Final

KEWAUNEE NUCLEAR POWER PLANT

DOCKET NO. 50-305

Comments on Draft Environmental Statement

Figure. III-15. WATER USAGE BY THE KNPP.

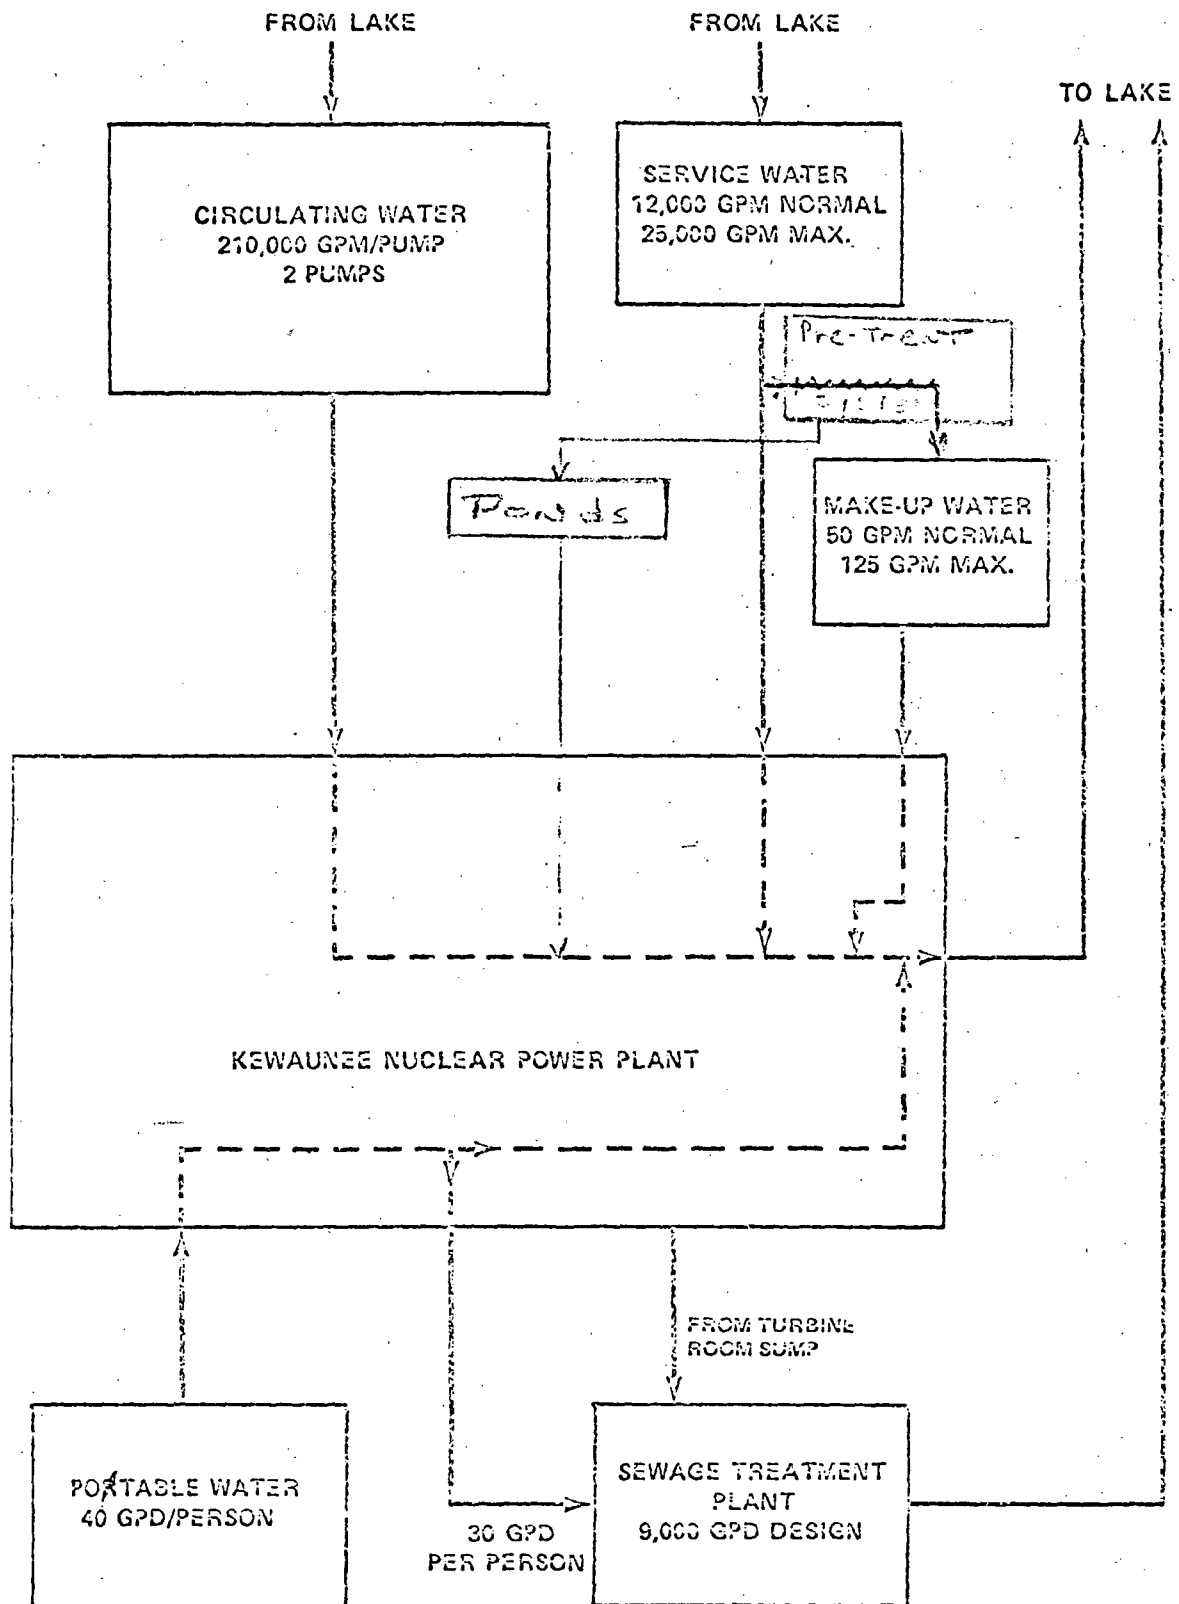
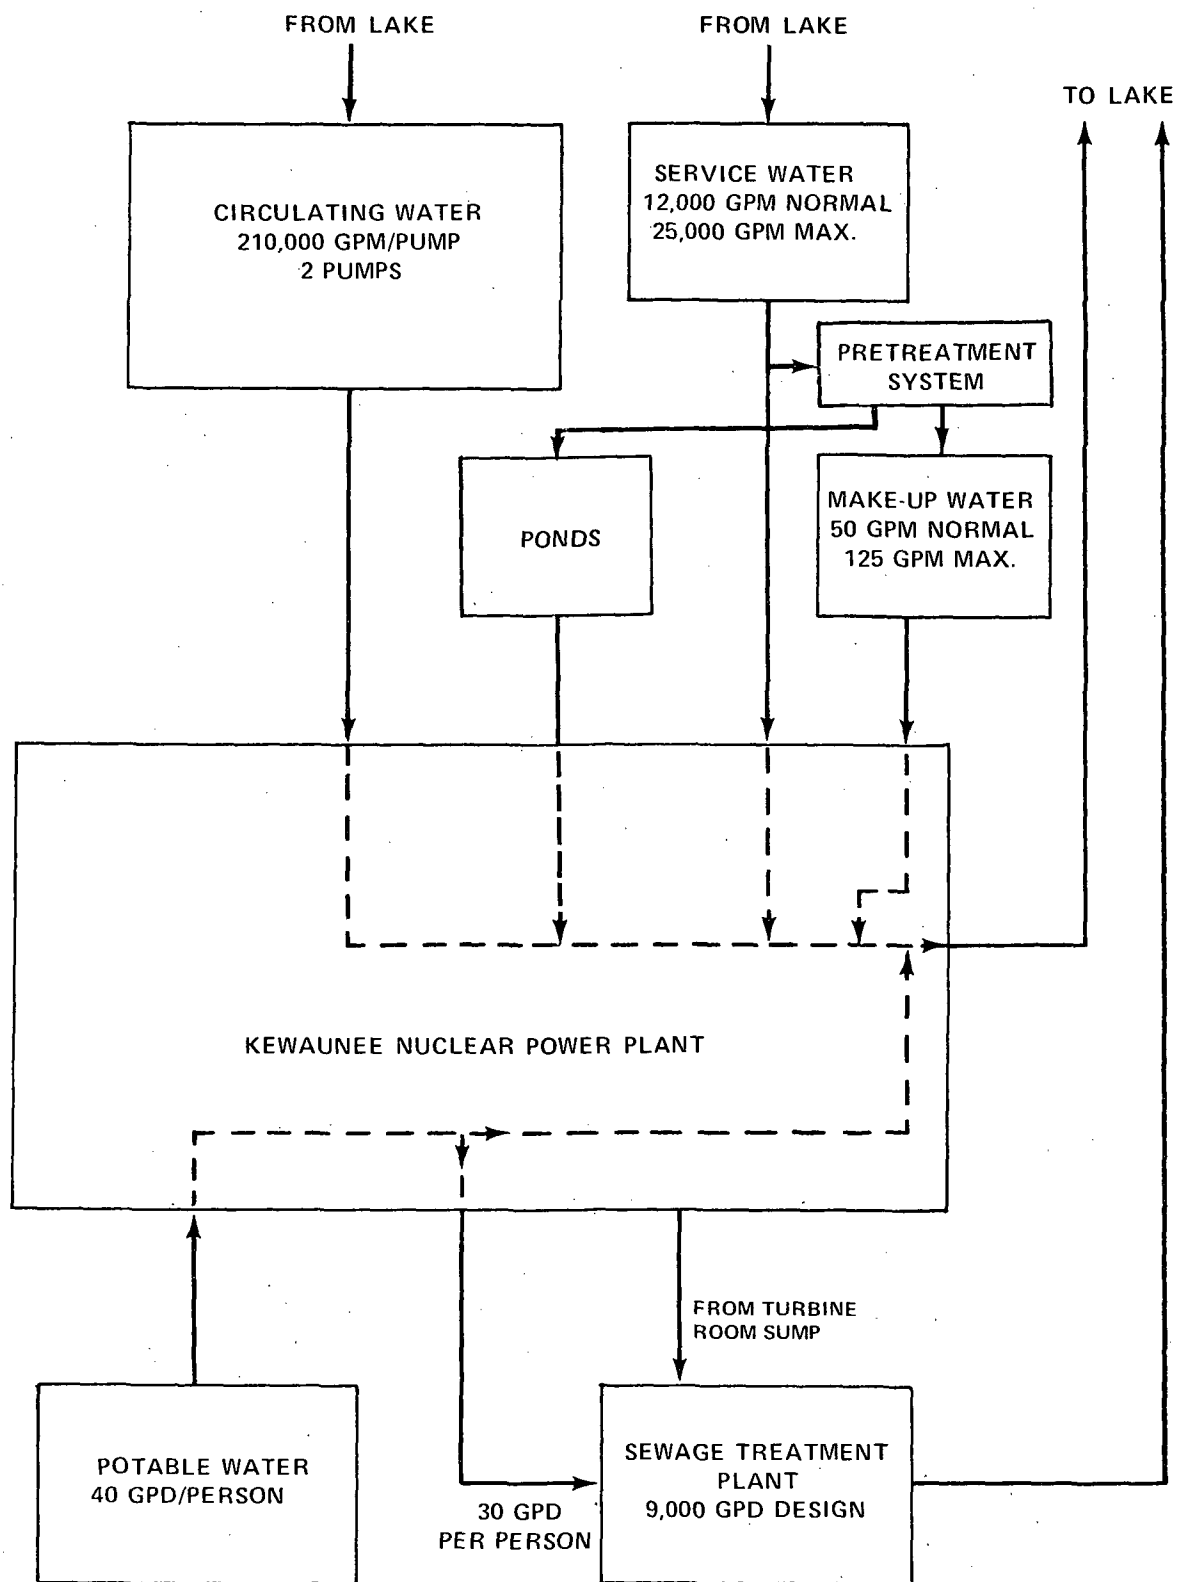
<u>Comment No.</u>	<u>Ref. Page, Figure, Table</u>	<u>Remarks</u>
1	Page II-24	Last paragraph - Analysis of surface wells mineral content have shown values of 840 ppm rather than 330 ppm.
2	Page III-23 Figure III-13	WPS has agreed to modify the steam generator blowdown treatment vent to vent to the condenser instead of venting to atmosphere.
3	Figure III-14	See attached Figure III-14 indicating flow paths.
4	Page III-26	Top of page - Last sentence change to: "Alternatively, the bottoms can be sent directly to waste solidification for processing."
5	Page III-30	Item 2, secondary coolant, boiler blowdown of coolant containing chemicals are discharged directly to the lake by way of the circulating water and are not routed to the neutralizing tank.
6	Page III-30	WPS has modified the make-up water system. (See attached - Service Water Pretreatment System.)
7	Figure III-15	See attached Figure III-15 indicating changes.
